## Application for a licence amendment

<b>Licence number</b>	L9413/2023/1
<b>Licence holder</b>	FBROS Pty Ltd
<b>ACN</b>	634 416 078
<b>File number</b>	DER2023/000675
<b>Premises</b>	Funk Cider 2.0 38 Swan Street, HENLEY BROOK, WA 6055 Legal description Lot 123 on Plan 3820 As defined by the premises map in Schedule 1
<b>Date of report</b>	25 November 2024
<b>Decision</b>	Granted

## Amendment description

**Figure 1: Daily rainfall for Millendon (Swan Valley) (nearest weather station to Henley Brook (about 10 km) (Bureau of Meteorology (BOM) Daily Rainfall data – Millendon (Swan Valley)).**

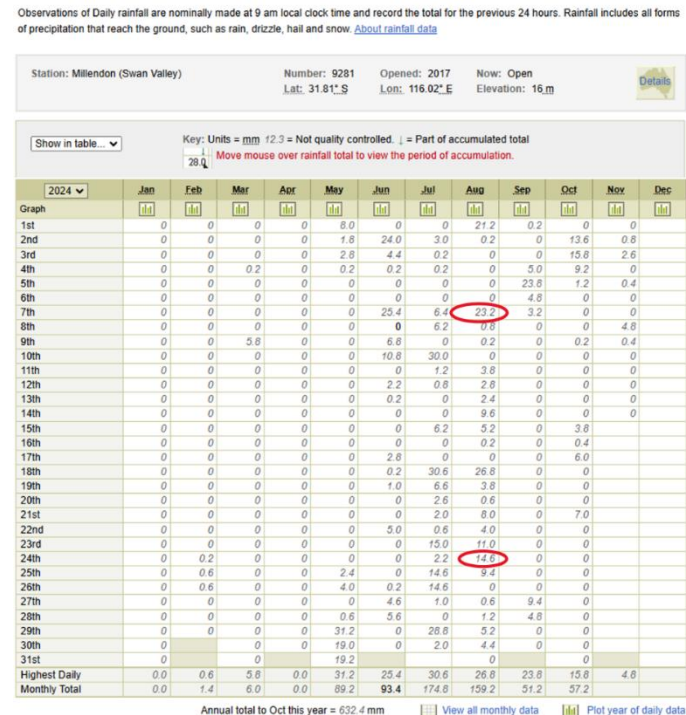
(j) Ponding in vineyard – the stakeholder has outlined that photographs taken during the winter months in 2023 and 2024 show ponding on the soil surface after rain. Photographs of the vineyard have been provided for the dates 12 May 2024, 7 August 2024 and 24 August 2024,

(j) Photographs from 7 and 24 August 2024 show pooling in the irrigation area, but rainfall on those dates was 23.2 mm and 14.6 mm, well above the area’s average of 5 mm per day (BOM data). These conditions likely represent above-average rainfall, not typical irrigation conditions. Aerial imagery from 16 June, 6 April, and 14 September 2024 shows no significant pooling. The licence also includes controls to prevent irrigation during or within 24 hours of rainfall over 2 mm (Condition 3, Table 2, row 4(b)).
